Our reference – 5696 05.1.11  
Attention: Peter Staveley

**RE: SOUTHERN EMPLOYMENT LANDS AMENDMENT TO APPROVAL**

# AMENDED MASTERPLAN

## MASTERPLAN - Lot Plan

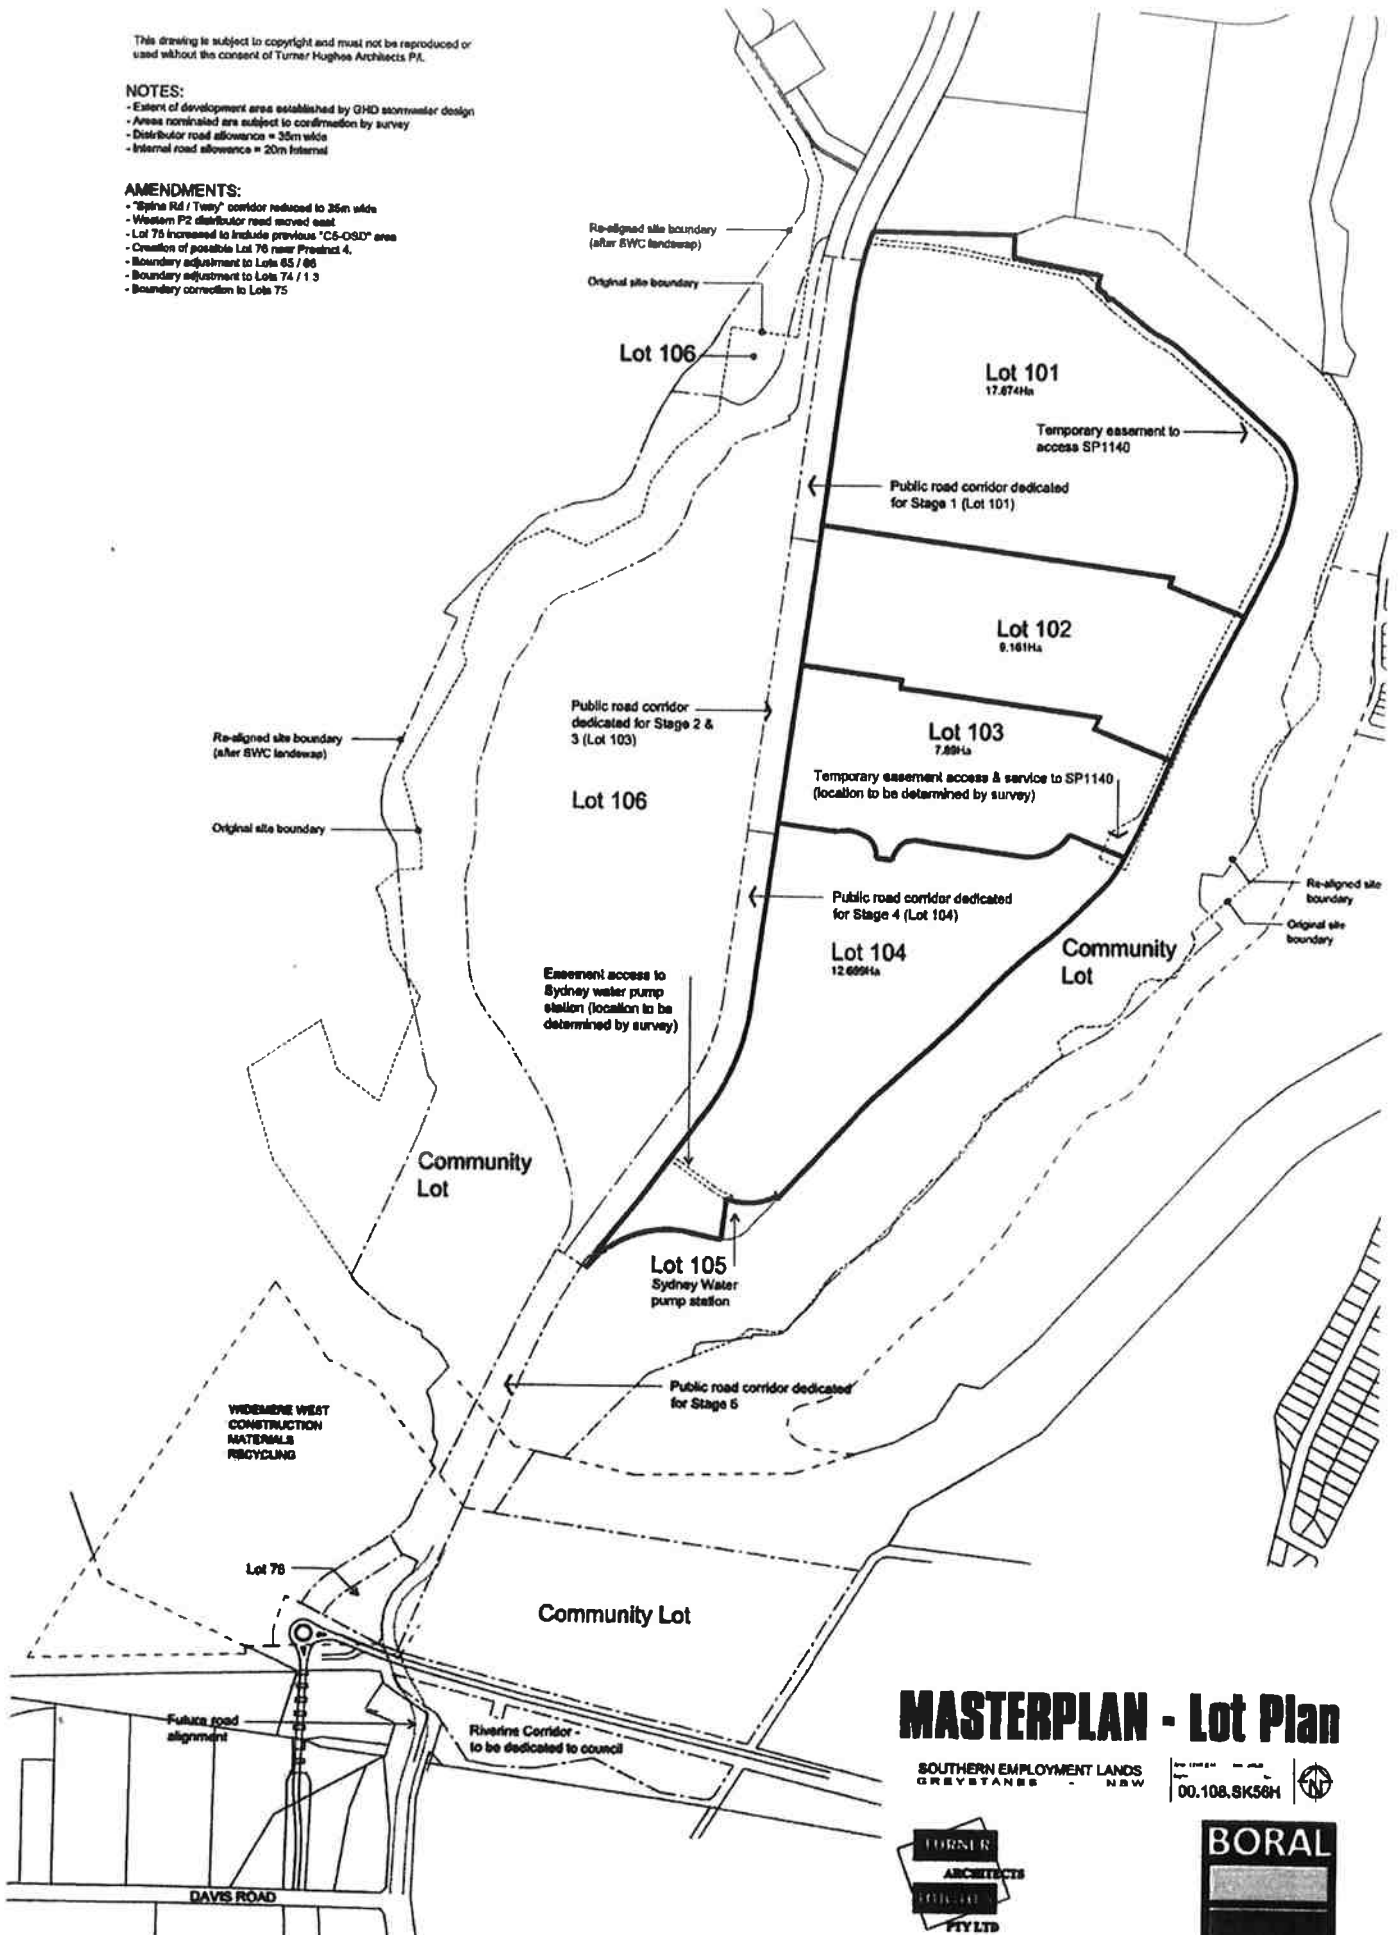
The following amendments to the subdivision layout are indicated on the plan ref 108-SK60H (*Annex A*). It is requested that Conditions of the Concept and Project approval be amended to reflect the amended plan and the creation of 76 lots.

- "Byline Rd / Tway" corridor reduced to 35m wide
- Western P2 distributor road moved east
- Lot 75 increased to include previous "C5-C5D" area
- Creation of possible Lot 76 near Precinct 4
- Boundary adjustment to Lots 65 / 66
- Boundary adjustment to Lots 74 / 13
- Boundary correction to Lot 75

## CONCEPT MASTERPLAN

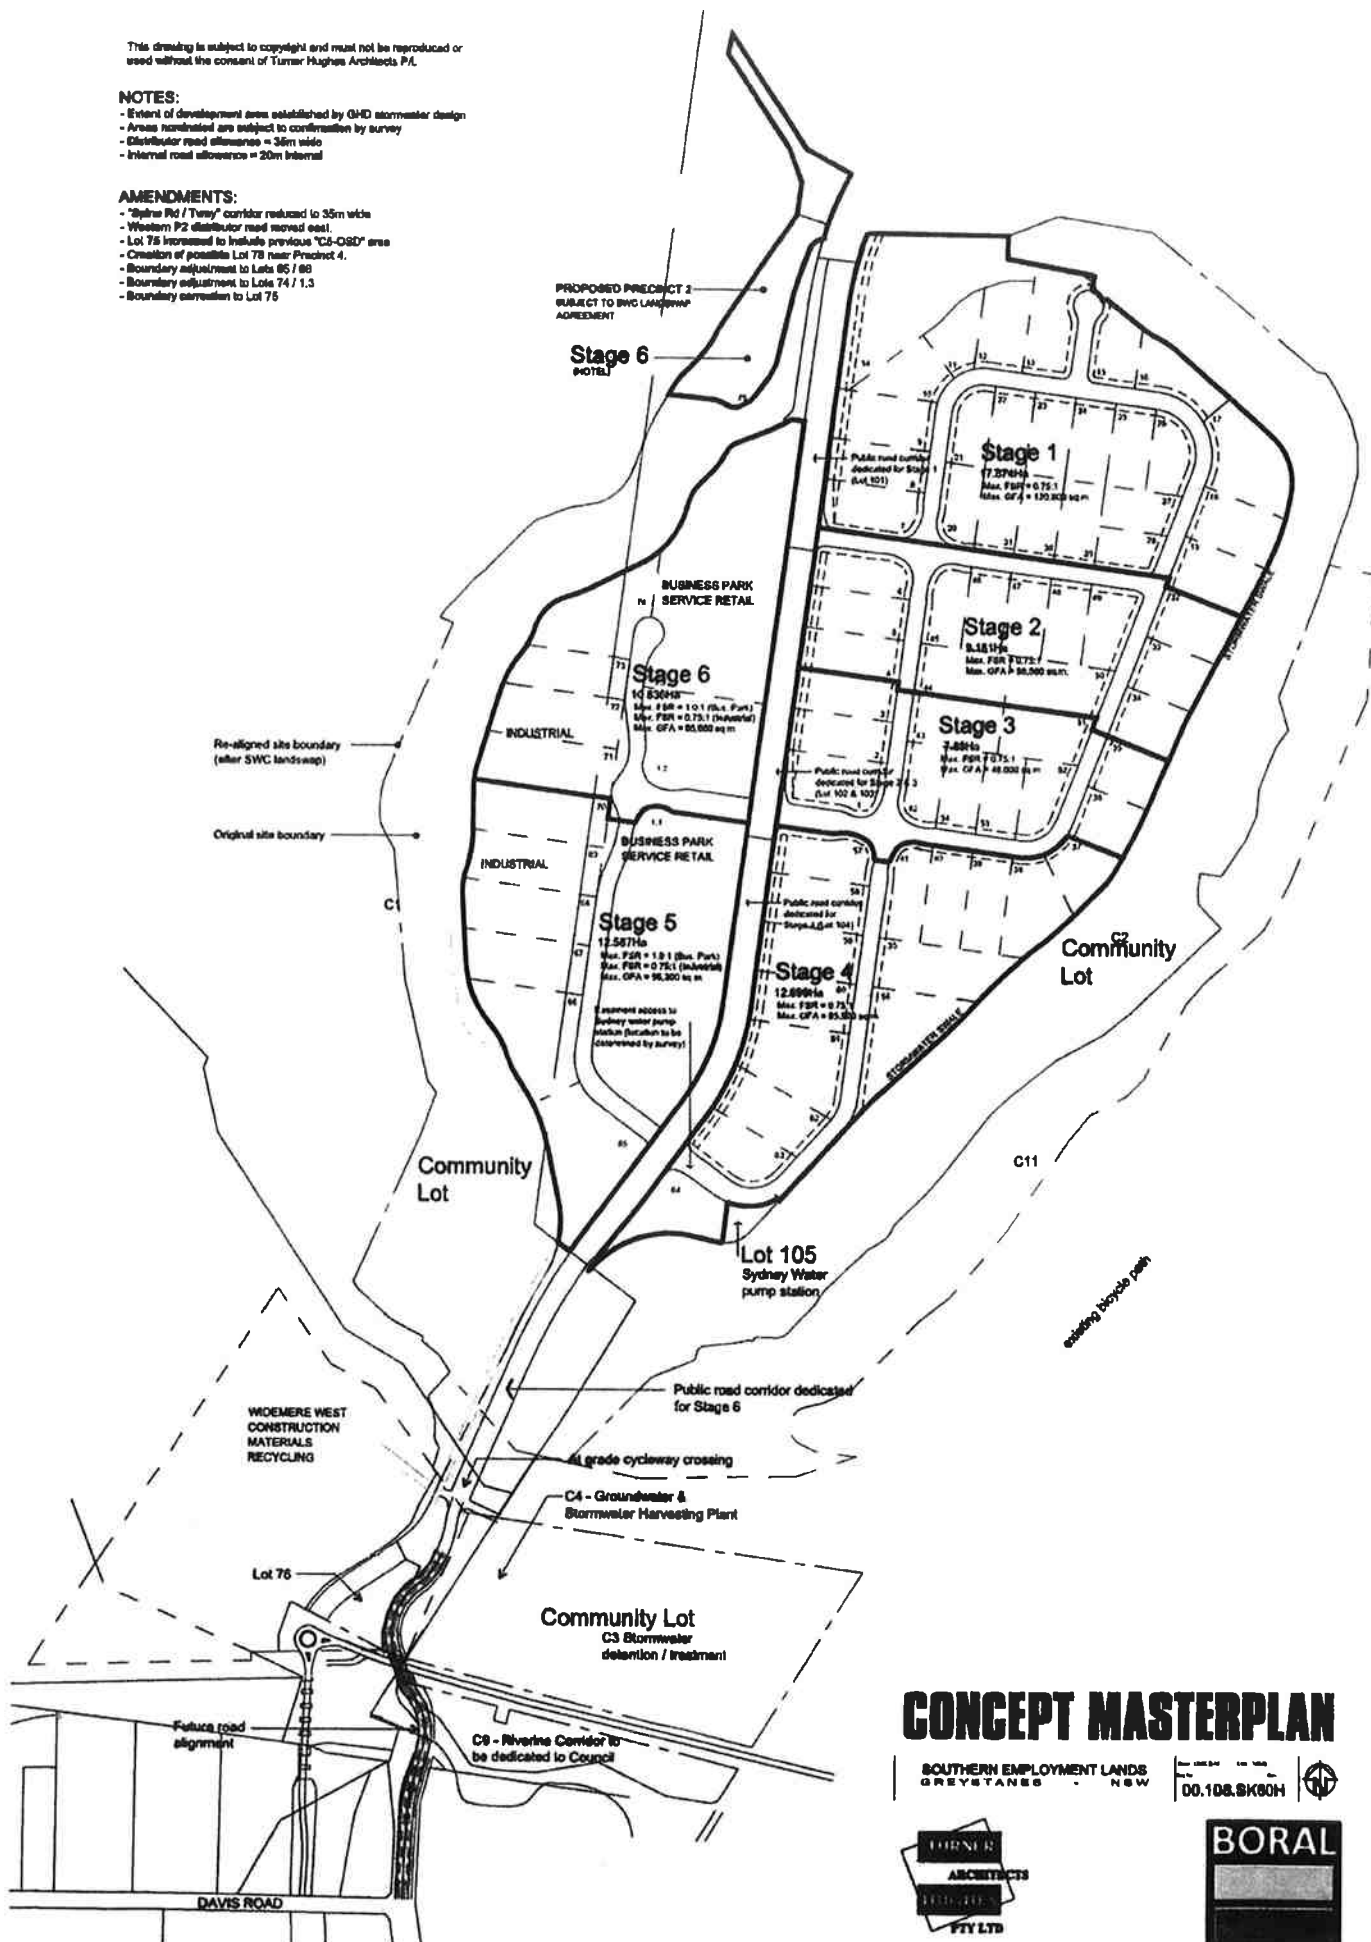
- "Sydney Rd / Tenny" corridor reduced to 35m wide
- Western P2 distributor road moved east
- Lot 75 increased to include previous "C6-C8D" area
- Creation of possible Lot 78 near Precinct 4
- Boundary adjustment to Lots 85 / 86
- Boundary adjustment to Lots 74 / 1.3
- Boundary extension to Lot 76

# PLAN REF SK0056 REV A

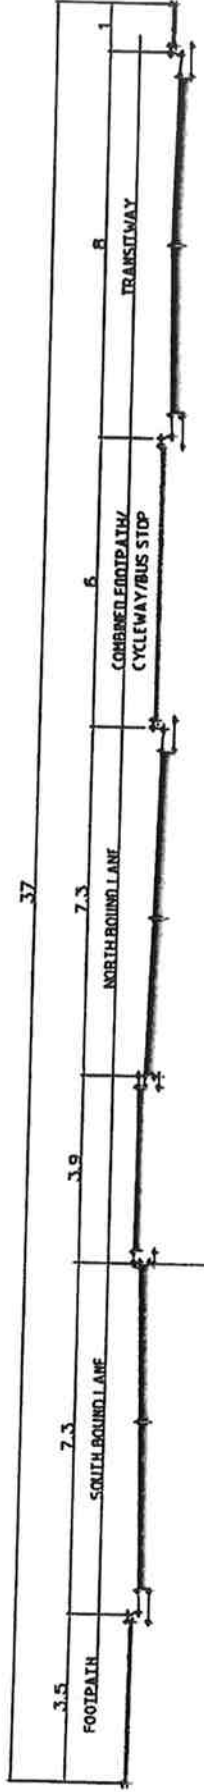
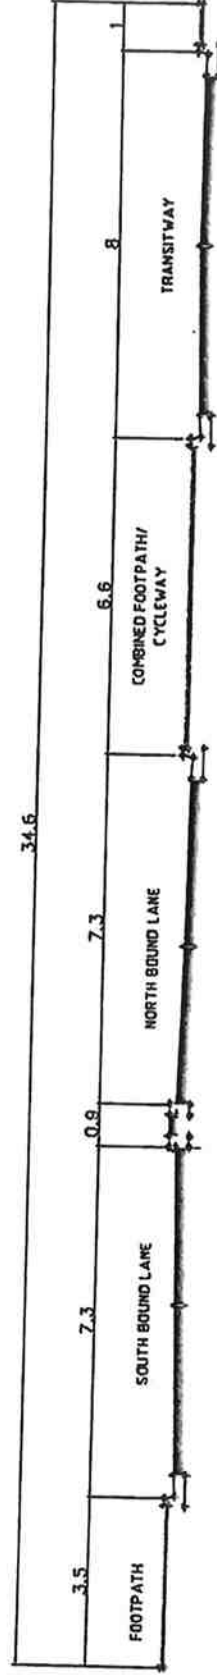
Typical cross sections of the Spine Road/Transitway corridor are shown on Drawing 5696-SK0056 attached.

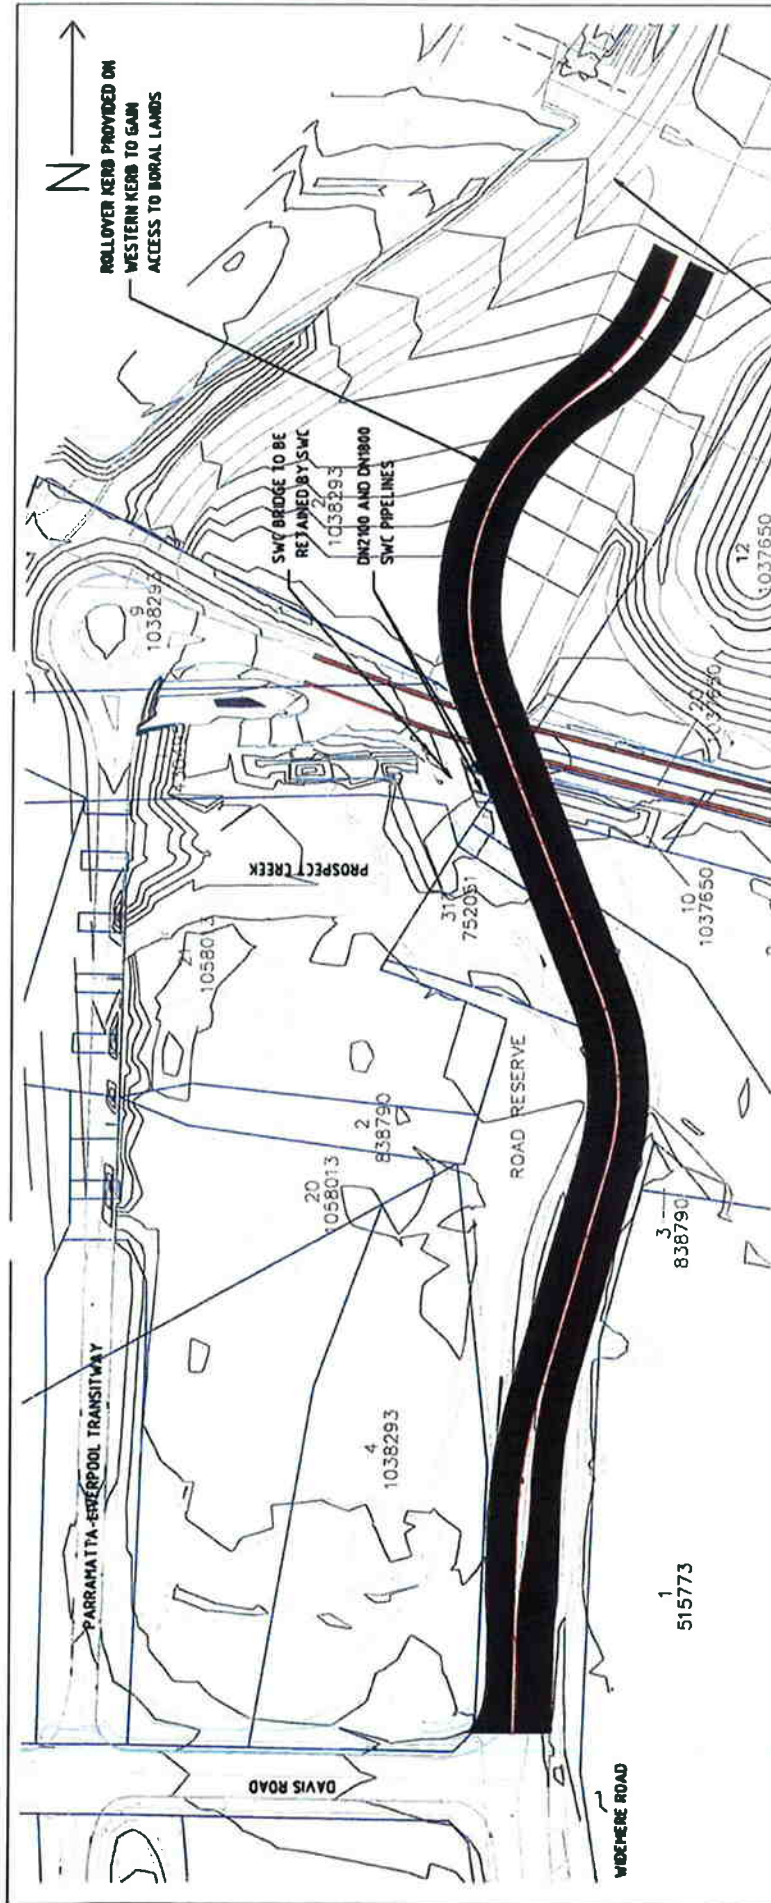
An alternative alignment and crossing has been investigated that enables the road to be constructed on land owned by Boral, land within existing road corridors, Fairfield City Council owned land and on Crown land adjacent to the road reserve and provides for low level bridging of the water mains to the east of the current bridge. This road would connect to Widemere Road and provide four lane road width to the Davis Road Intersection. Through traffic from the north can proceed either south along Widemere Road or west on Davis Road providing a dispersal of traffic in the area.. A plan illustrating this proposal is attached (refer *Annex D*).

Access from the Spine Road to proposed Lot 76 will be provided through a roll over kerb with left in/out access only (refer to Drawing 5696-SK-0048 attached). Note that the proposed use for this lot is now only for a site entry statement or signage and hence access only required for ad-hoc maintenance.

The Southern Road Connection (SRC) shall be completed from the Widemere Intersection up to the Davis Road/Widemere Road intersection generally in accordance with Drawing 5696-SK-0048 rev F. Traffic lights at the Widemere Road/Davis Road intersection shall be installed by the relevant authorities following construction of the road and as required by traffic flows. Line marking will be applied to this intersection to facilitate traffic. The SRC shall comprise two lanes in both directions with a 3.5m services allocation including shared foot/cycle path on the eastern side. The geometric design of the SRC will be compatible with a design speed of 40km/h. Design speed is as defined in RTA road design guide (current edition). The SRC will accommodate B-Double vehicles.
